**GE Hitachi Nuclear Energy**

Subject: **Response to Portion of NRC Request for Additional Information Letter No. 301 Related to ESBWR Design Certification Application ESBWR RAI Numbers 22.5-22, S01, 22.5-24 S01 and 22.5-30 through 22.5-46**

**RAI Numbers 22.5-22 S01, 22.5-24 S01 and  
22.5-30 through 22.5-46**

Figure 2.6.2-1. Fuel and Auxiliary Pools Cooling Cleanup System

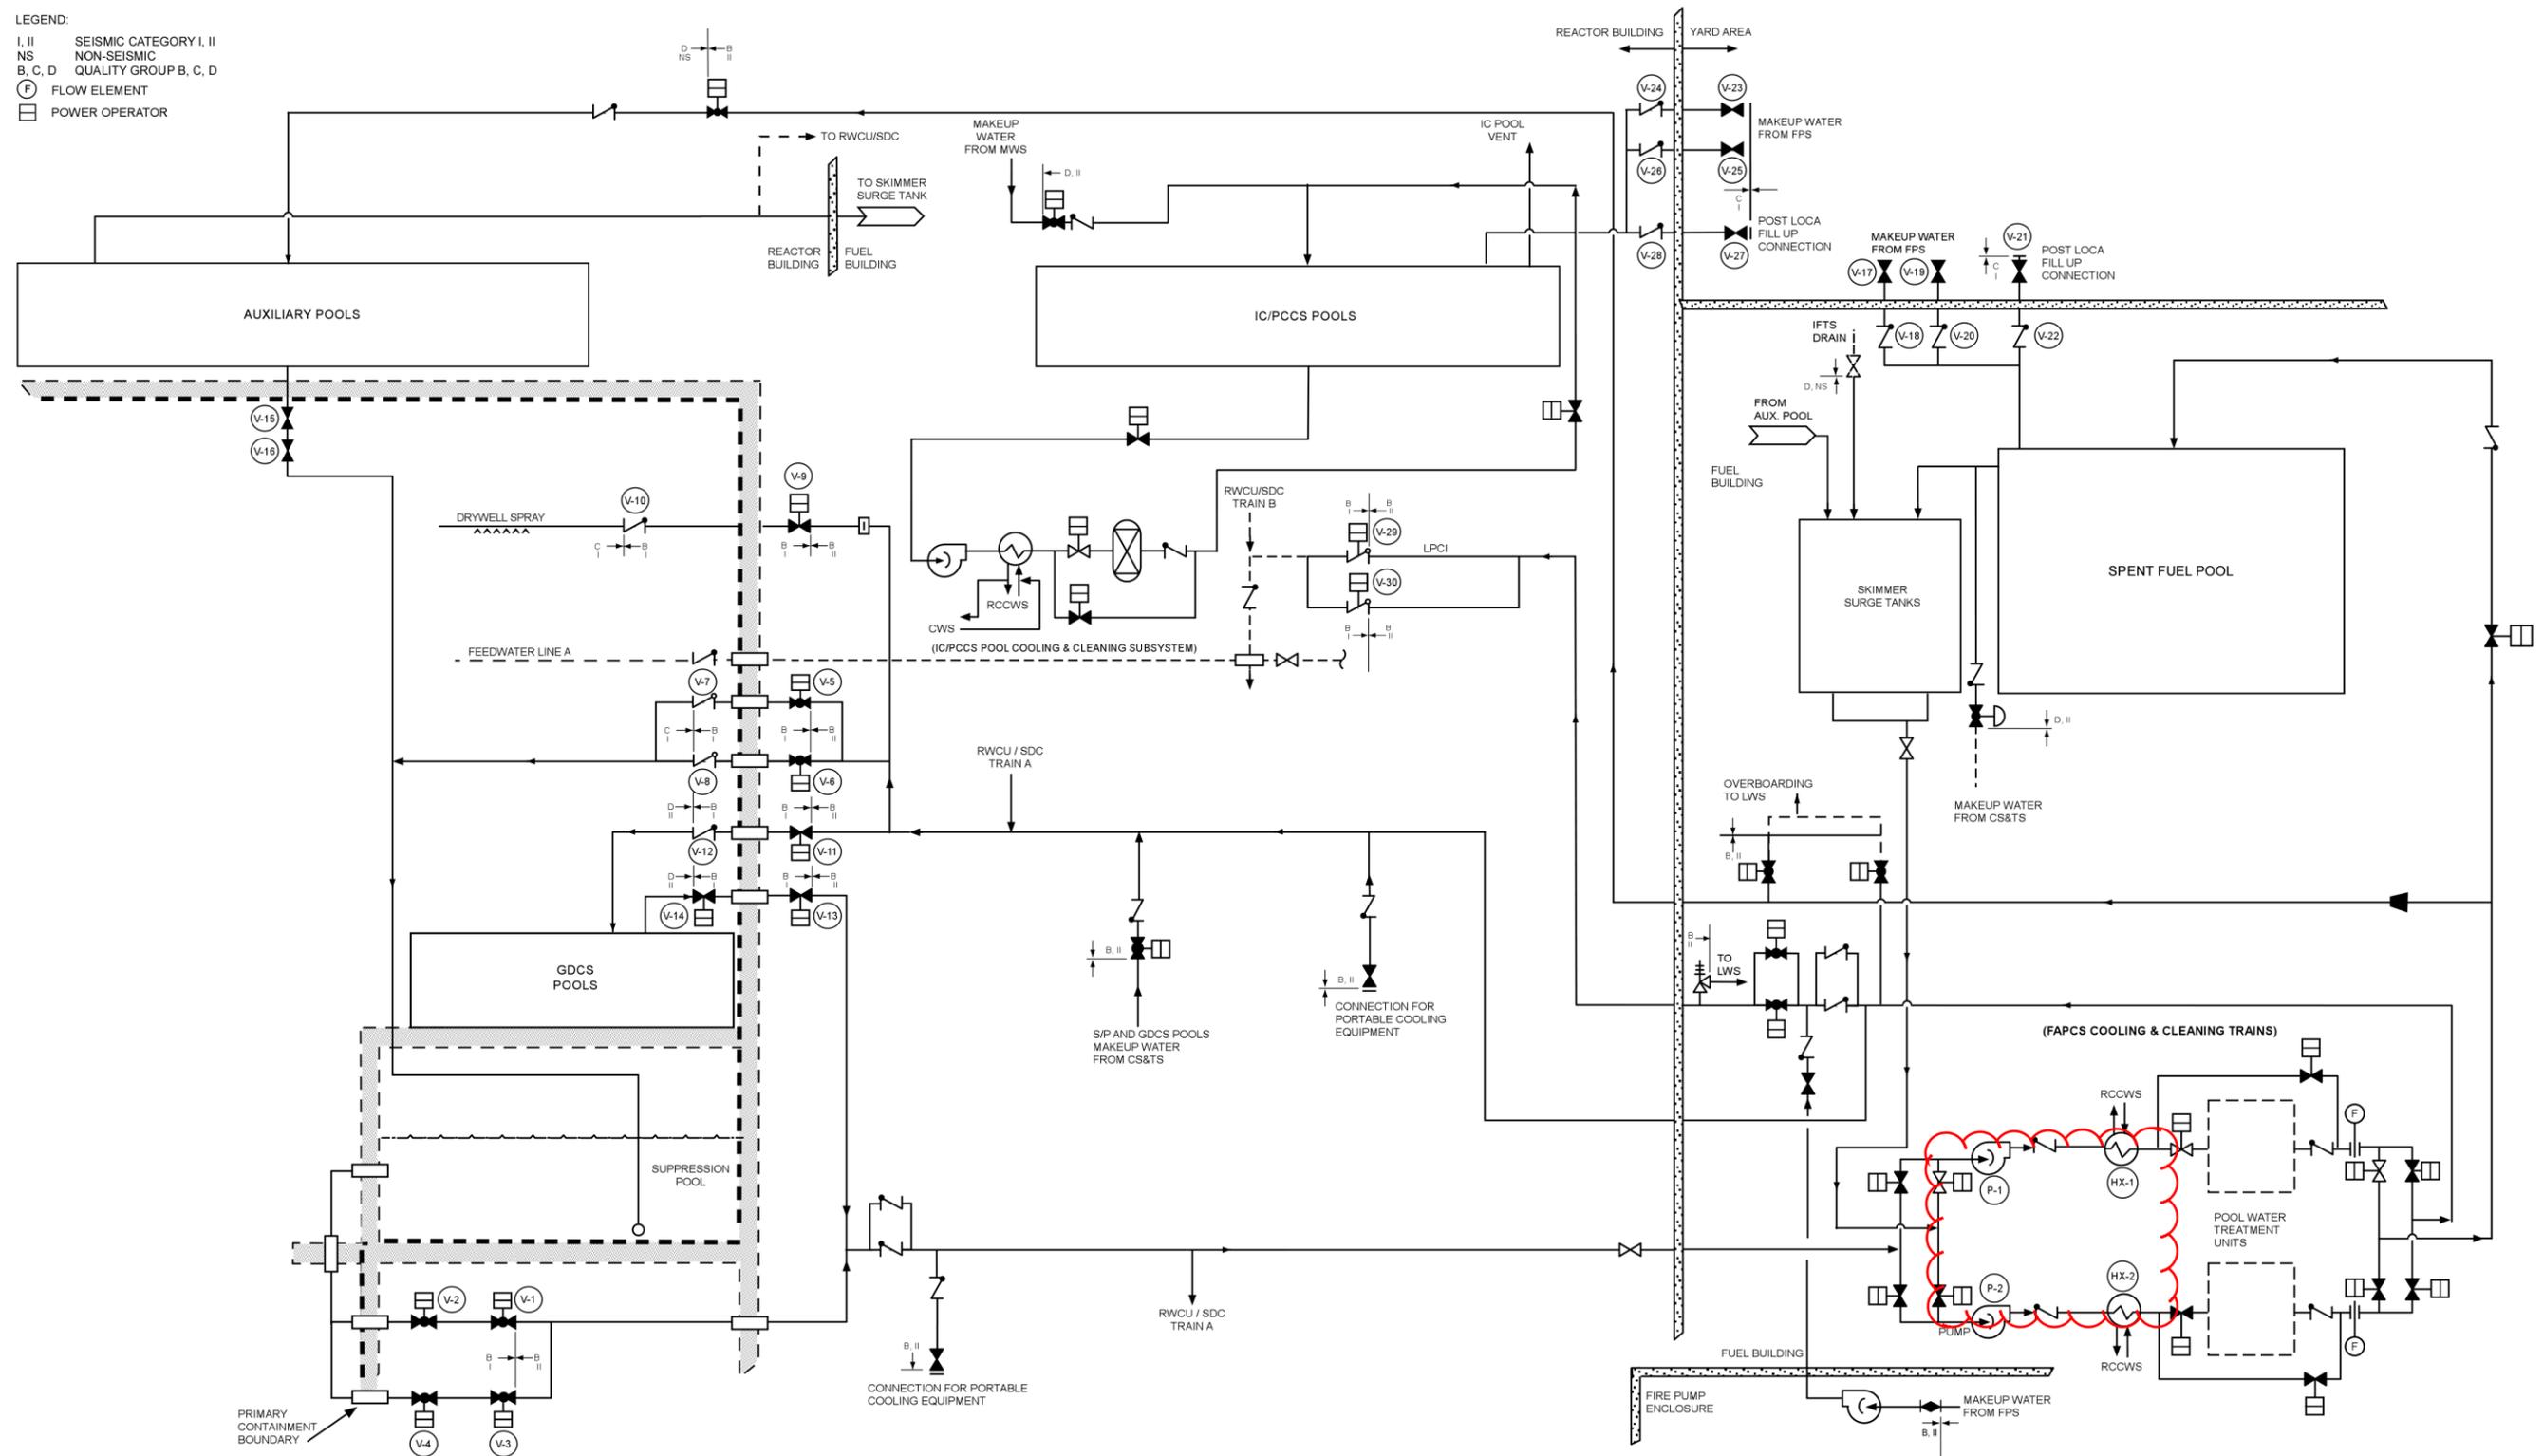
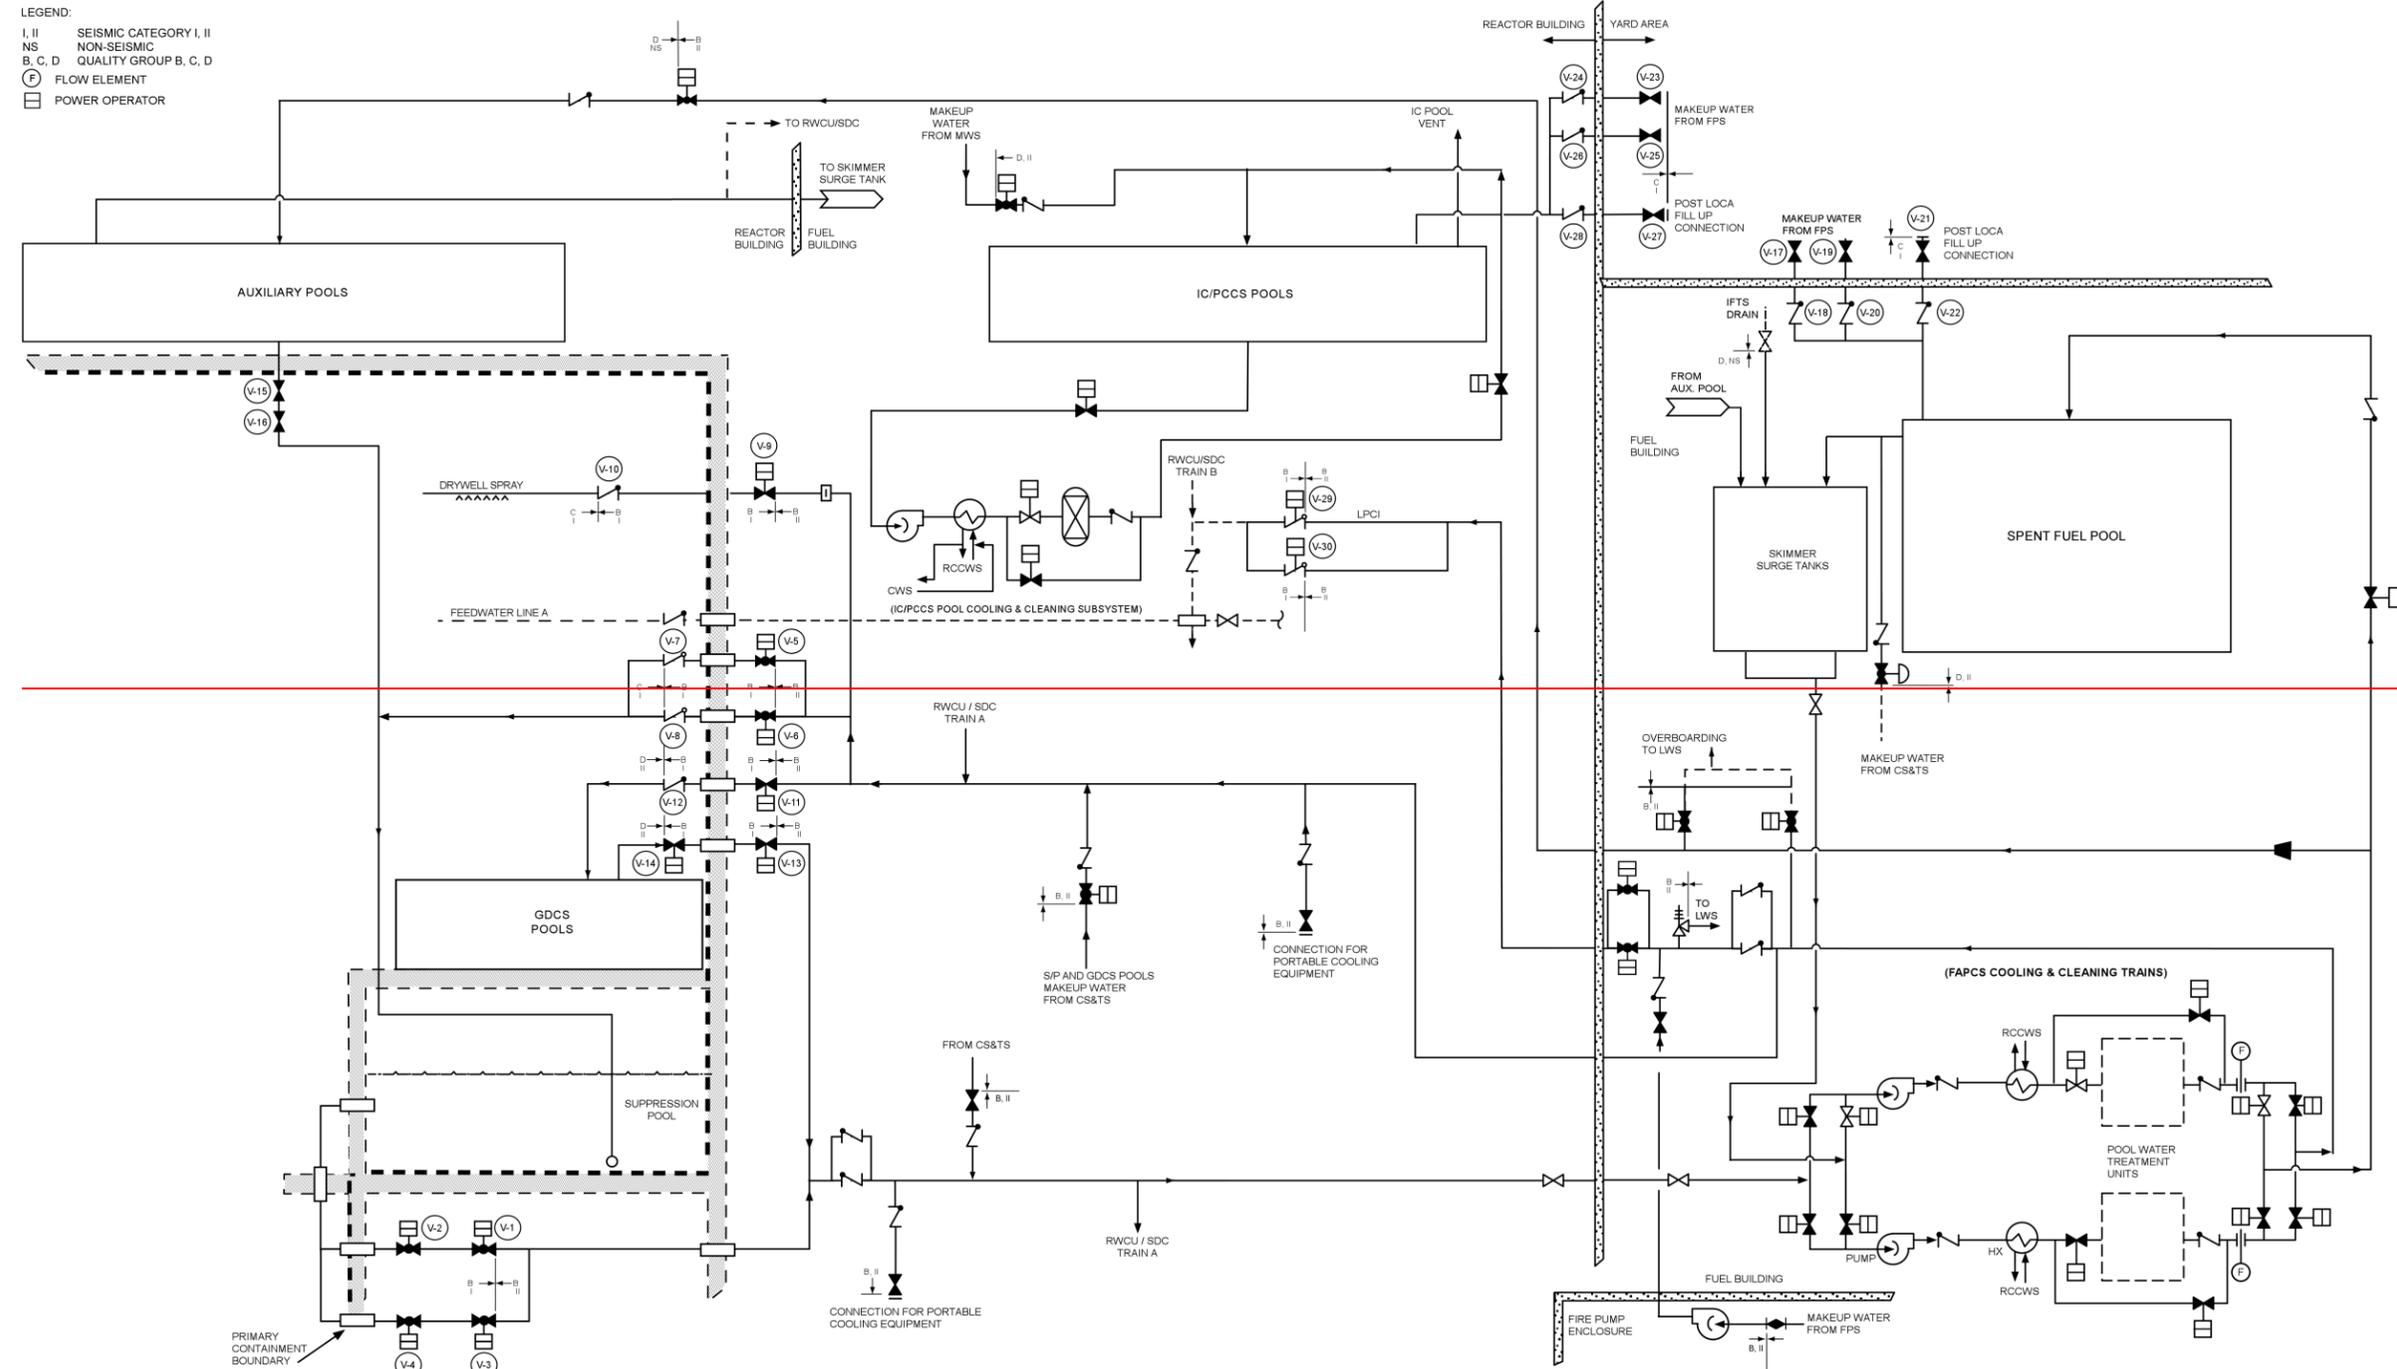
GEH will revise Table 2.6.2-1 to include the FAPCS pumps in the list of mechanical components.

DCD Tier #1, Table 2.6.2-1 and Figure 2.6.2-1 will be revised in Revision 6 as noted in the attached markup.
